**CITY OF MUSKEGON
HISTORIC DISTRICT COMMISSION
REGULAR MEETING**

DATE OF MEETING: Tuesday, April 6, 2021
TIME OF MEETING: 4:00 p.m.
PLACE OF MEETING: <https://www.facebook.com/CityofMuskegon>

AGENDA

Minutes Attachment A

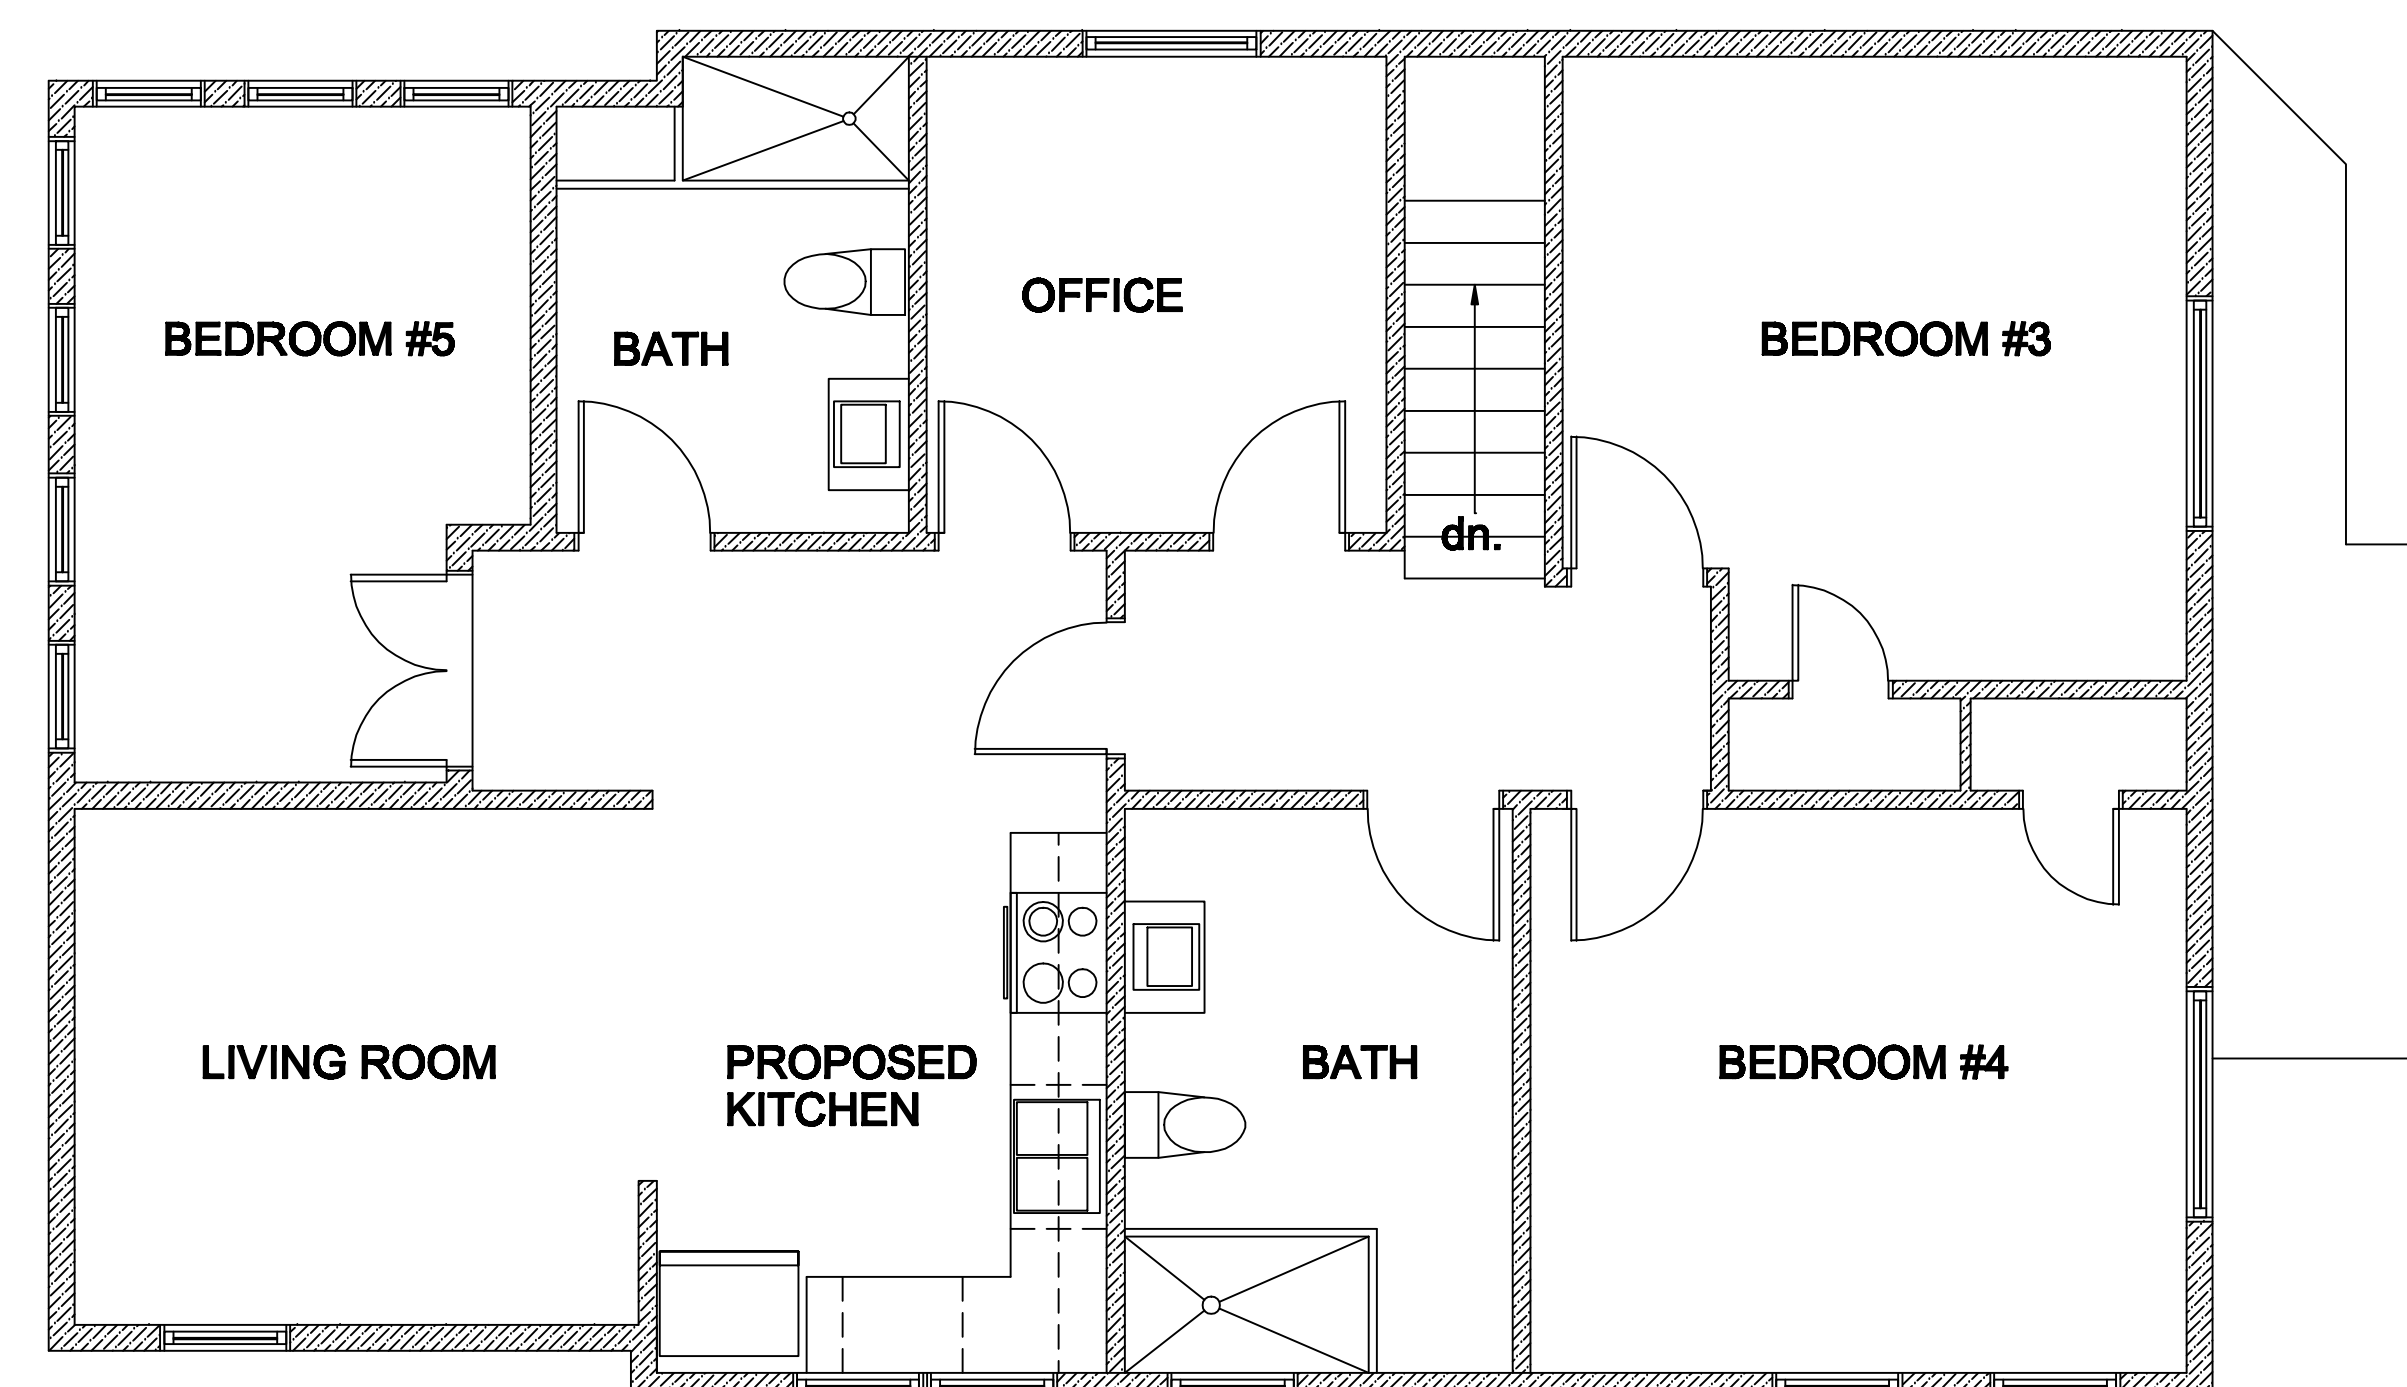
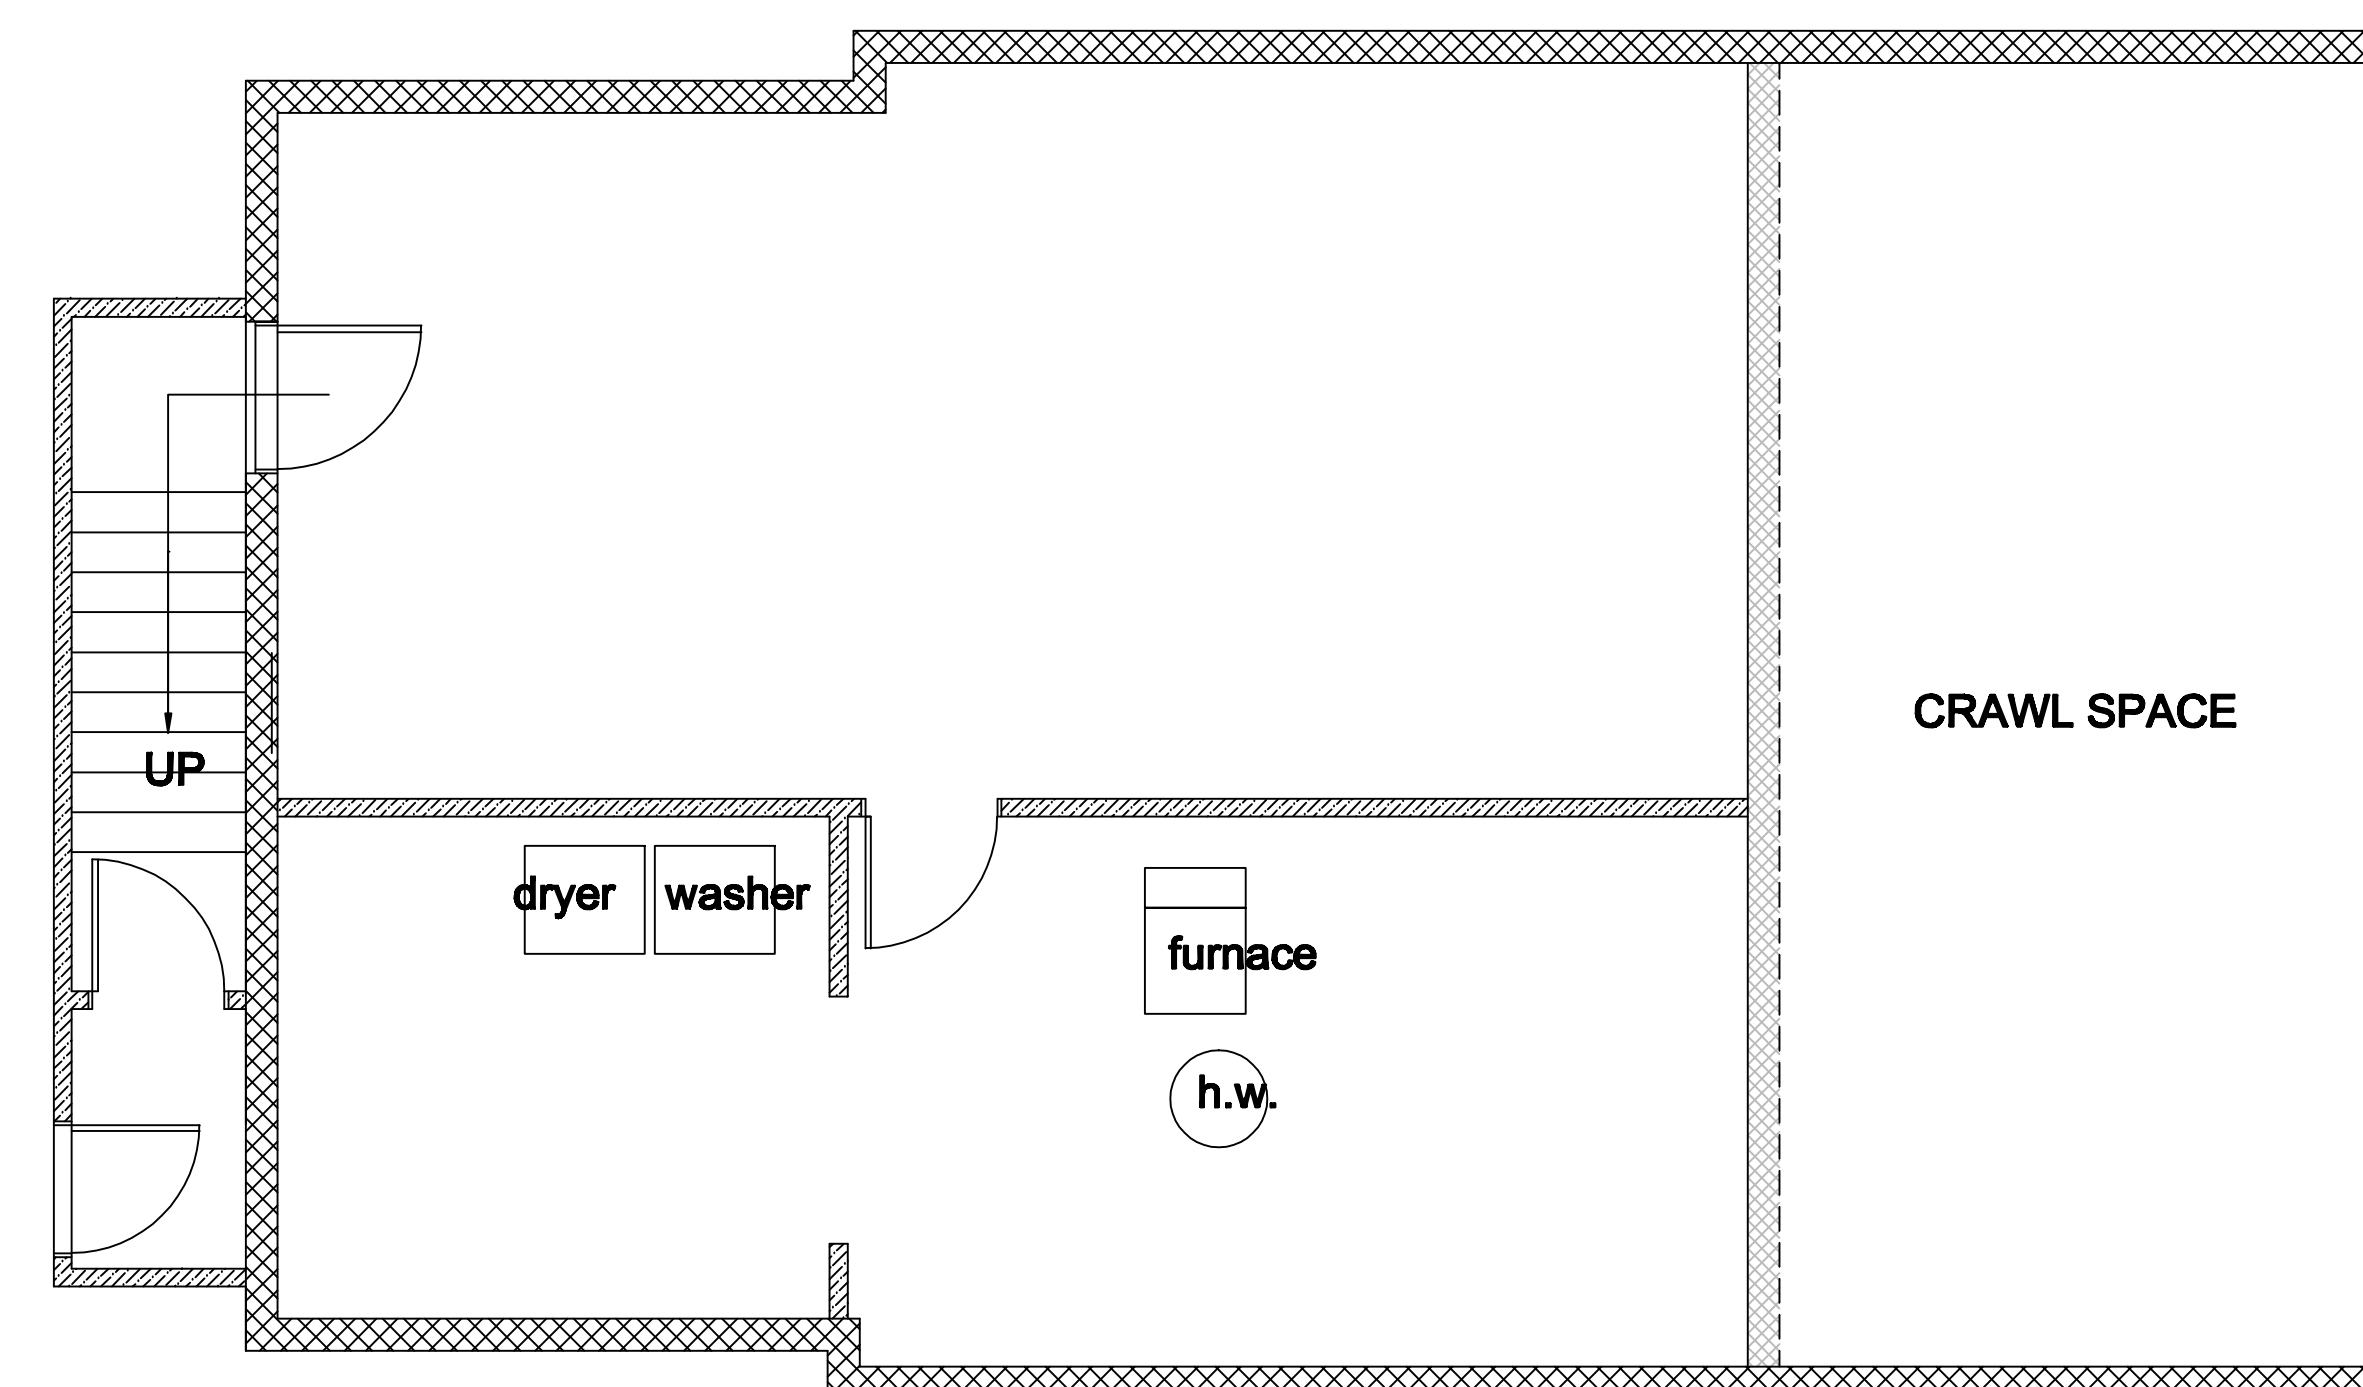
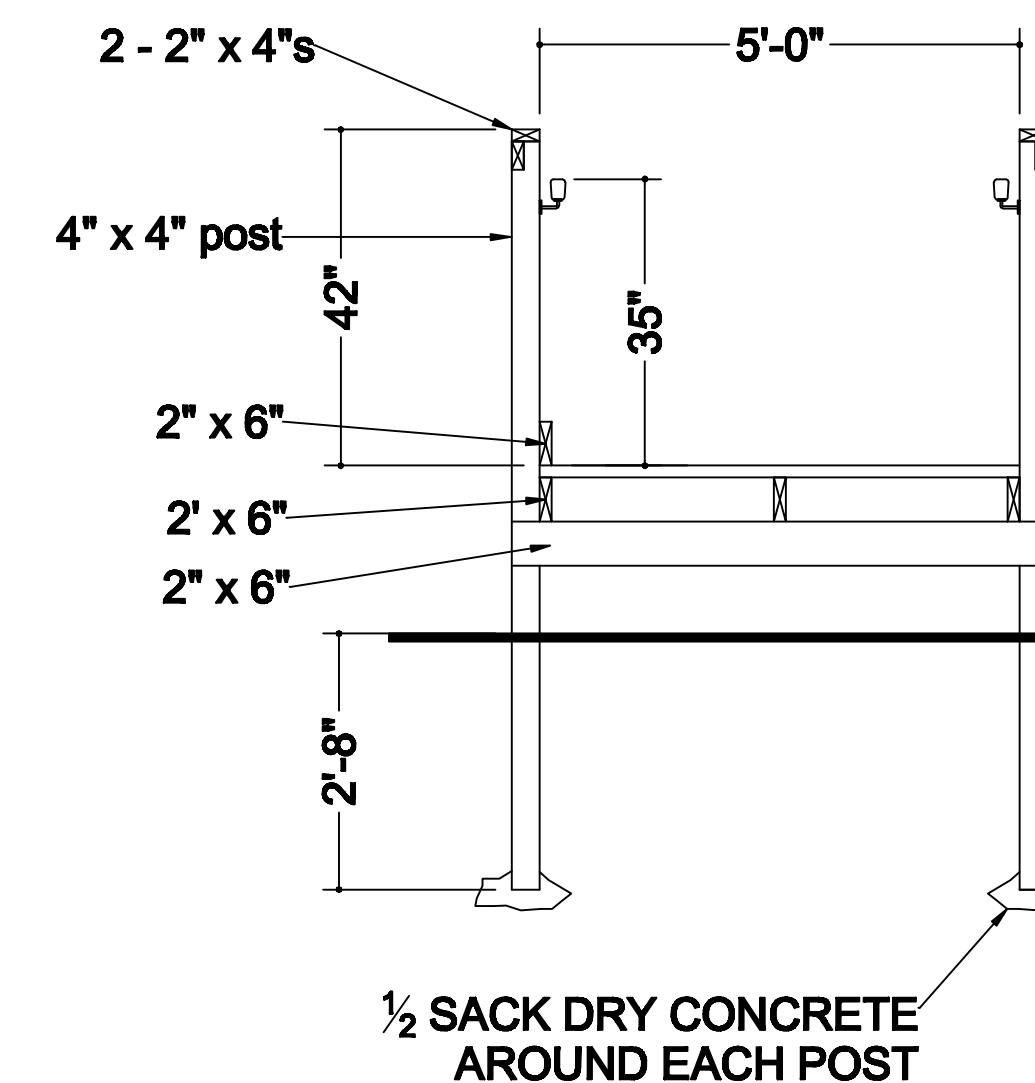
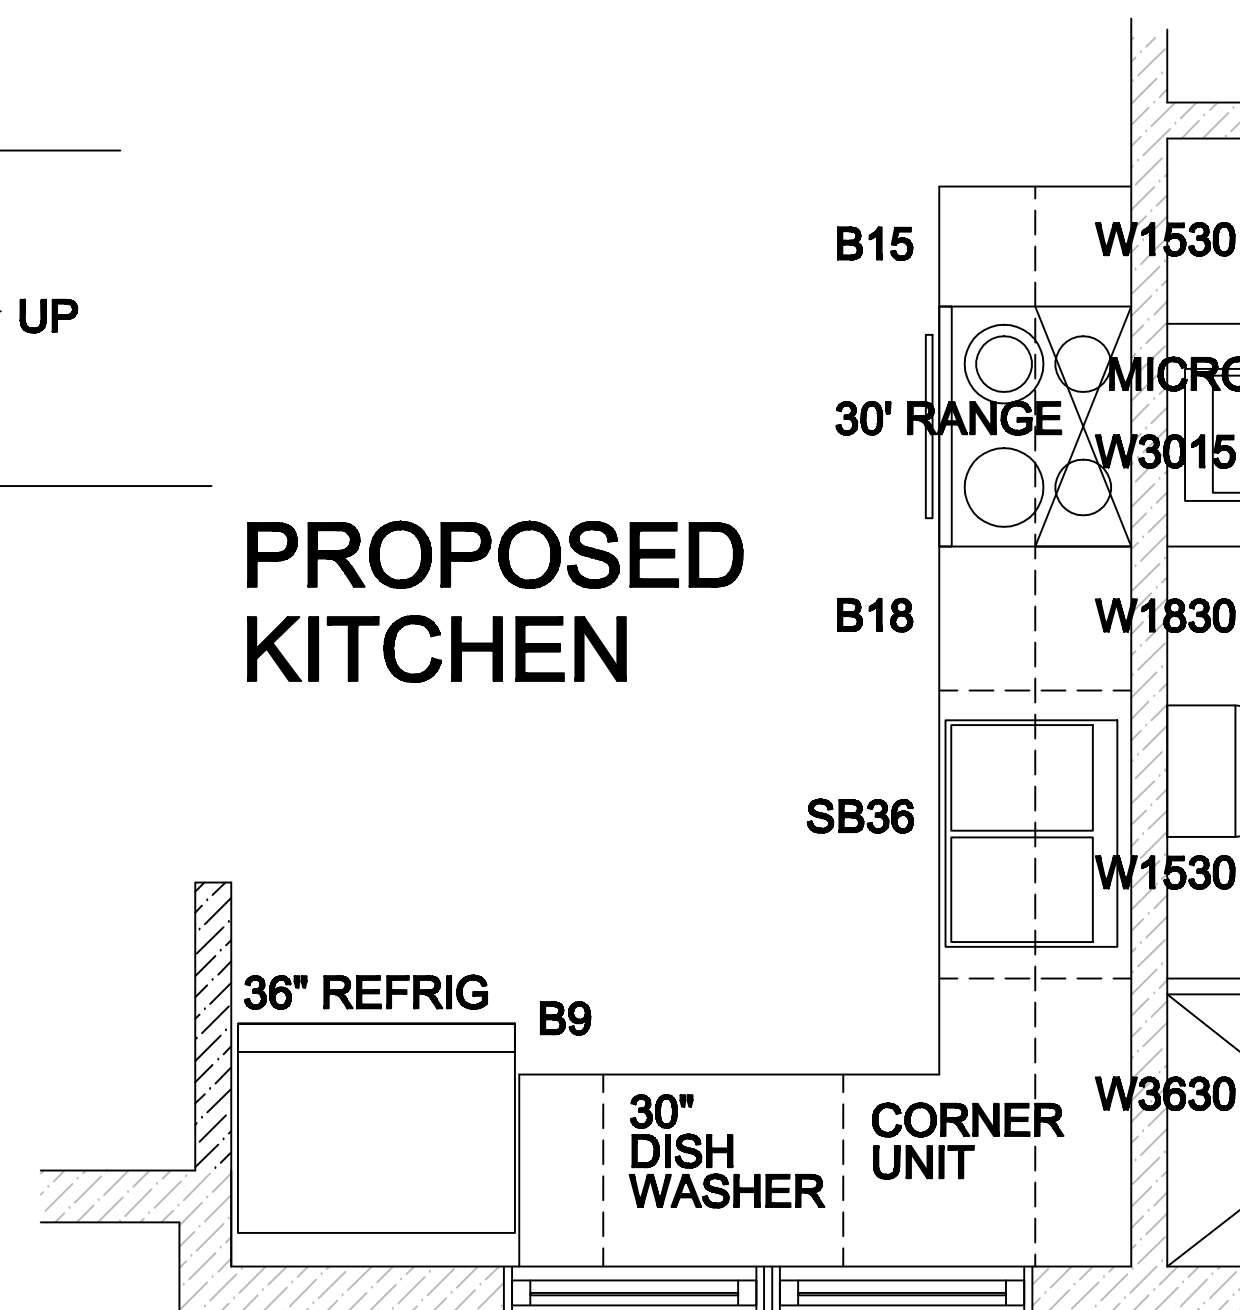
Case 2021-07 (Walk-on) – 1129 Peck Street (Accessible Ramp). Applicant: Step Up (Dick Kamps). District: McLaughlin. Current Function: Residential. J. Pesch presented the walk-on case. The applicant is seeking approval to install a new accessible ramp on the north side of the house. J. Pesch shared plan and elevation drawings for the proposed ramp, and photos of the north side of the house looking east toward Peck Street from the alley and west toward the alley from Peck Street.

D. Kamps noted that the ramp would lead from the alley, up toward Peck Street, to an existing side porch and stated that the ramp would be hardly visible from the street. S. Radtke asked if the existing door was of an ADA-compliant size. D. Kamps stated that the door was ADA-compliant at 36"-wide. S. Radtke asked what type of skirting was proposed for below the ramp. After further review of the drawings and photos, the board agreed that the side of the ramp that would typically require skirting was barely visible from the street. A. Riegler stated that if the ramp was on a primary elevation, the board would be more concerned with the ramp matching the house or having certain details. She noted that she was less concerned about these points due to the fact that the ramp would not alter the house, could easily be removed, and was largely hidden from view. D. Gregersen added

that adding more details to the ramp would only draw more attention to it. S. Radtke pointed out that the drawing showed a plain handrail on the ramp with it open underneath.

A motion that the HDC approve the request to construct a new accessible ramp along the north side of the existing house at 1129 Peck Street as shown in the drawings reviewed at the March 2, 2021 HDC meeting (Attachment A, below) as long as the work meets all zoning requirements and the necessary permits are obtained, was made by A. Riegler, supported by T. Emory and unanimously approved, with S. Radtke, T. Emory, A. Riegler, and D. Gregersen voting aye.
